Work Order ID 129120

Item Name: Baggage Compartment Protector Wall

DART SERVICE INSTRUCTION

TO AMEND INSTALLATION INSTRUCTIONS IIN-D407-781-2 REV. A OR LATER APPROVED REVISION
AND INSTRUCTIONS FOR CONTINUED AIRWORTHINESS ICA-D407-781 REV. 3 OR LATER REVISION

**FIGURE 1 - D3879-1 BAGGAGE COMPARTMENT WALL
PROTECTOR - ALTERNATE INSTALLATION**

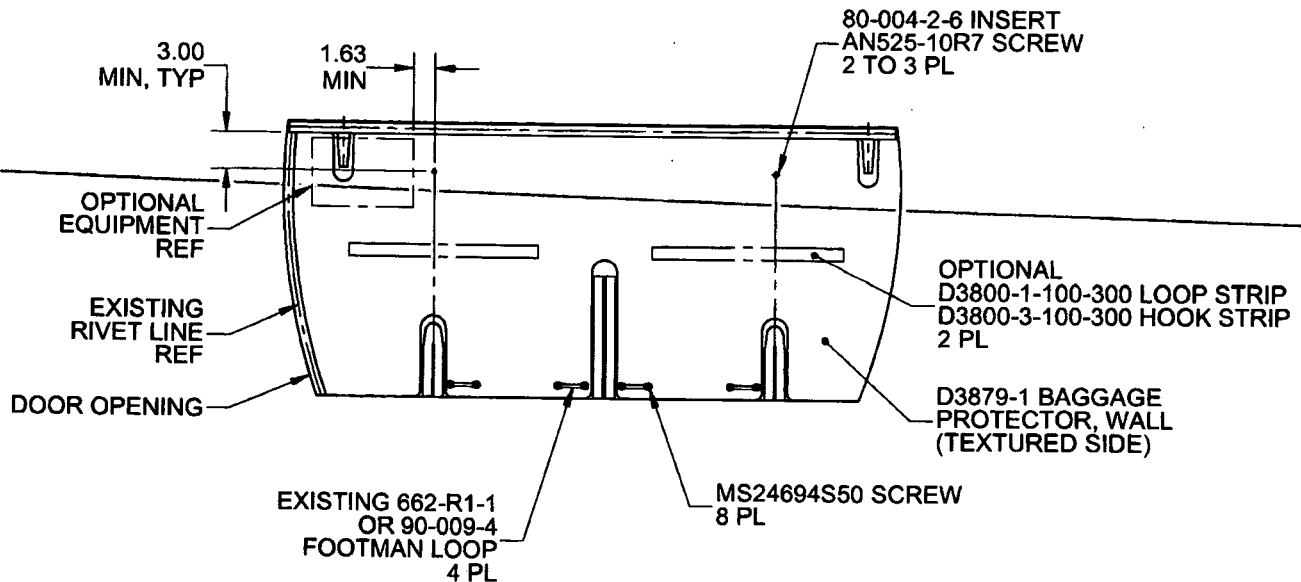
In some aircraft, the top portion of the D206-781-041 Baggage Compartment Wall Protector Kit cannot be installed as indicated in IIN-D407-781-2. The purpose of this DSI is to provide an alternate mounting method to fasten the top portion of the D206-781-041 Baggage Compartment Wall Protector Kit.

It is acceptable to replace qty(2) D3930-1 Clips with qty(2) 80-004-2-6 Inserts. Locate and mark location of the two attachment holes on the baggage compartment wall as shown in Figure 1 of this service instruction. Install 80-004-2-6 Inserts at the marked locations in accordance with Section 3-2-12 of BHT-206-SRM-1. It is acceptable to trim the wall protectors to accommodate optional equipment or transfer attachment holes to the wall protector and install the optional equipment on top of the wall protector with longer fasteners.

Amend the D206-781-041 Baggage Compartment Wall Protector Kit parts list as follows:

Qty -061	Qty -031	Qty -041	Part Number	Description
X			D206-781-061	BAGGAGE COMPARTMENT PROTECTOR KIT (FLOOR AND WALL)
1	X		D206-781-031	BAGGAGE COMPARTMENT FLOOR PROTECTOR KIT
1		X	D206-781-041	BAGGAGE COMPARTMENT WALL PROTECTOR KIT
		2	AN525-10R7	SCREW
		2	80-004-2-6	INSERT
